APPLICANT: Texas Utilities Electric Company (TU Electric)  
FACILITY: Comanche Peak Steam Electric Station (CPSES), Units 1 and 2  
SUBJECT: SUMMARY OF MEETING ON AUGUST 18, 1988 - APPLICATION OF  
LEAK-BEFORE-BREAK (LBB) METHODOLOGY TO THE PRESSURIZER  
SURGE LINE

LEAK-BEFORE-BREAK  
PRESENTATION TO THE NUCLEAR REGULATORY COMMISSION

## **II) 14" PRESSURIZER SURGE LINE**

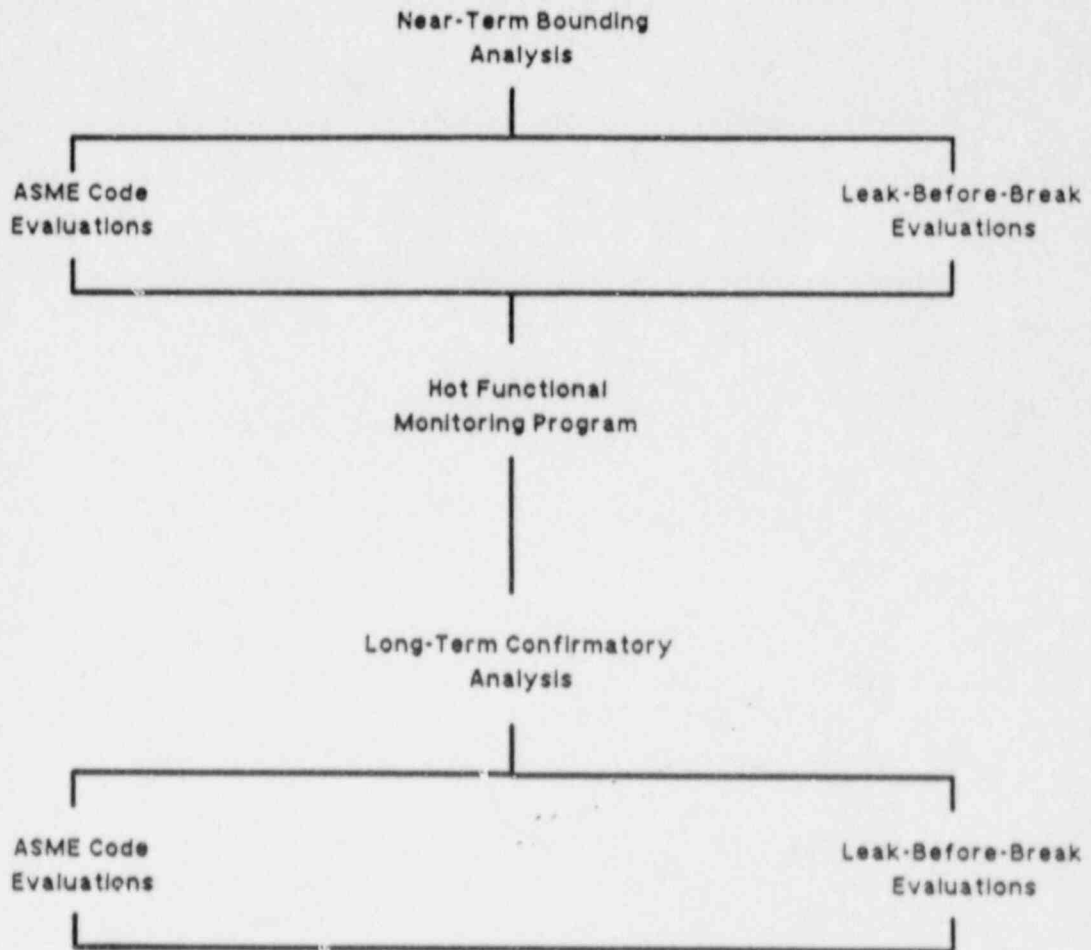
- **THERMAL STRATIFICATION EFFECTS OF THE PRESSURIZER SURGE LINE**
- **IMPACT OF STRATIFICATION EFFECTS ON LEAK-BEFORE-BREAK**

- **PERFORM UPDATED DETAILED ANALYSIS INCLUDING BOUNDING THERMAL STRATIFICATION ANALYSIS**
- **DEMONSTRATE LBB ACCEPTABILITY FOR THE SHORT TERM**
- **EXTEND LBB APPLICABILITY FOR 40-YEAR PLANT LIFE**
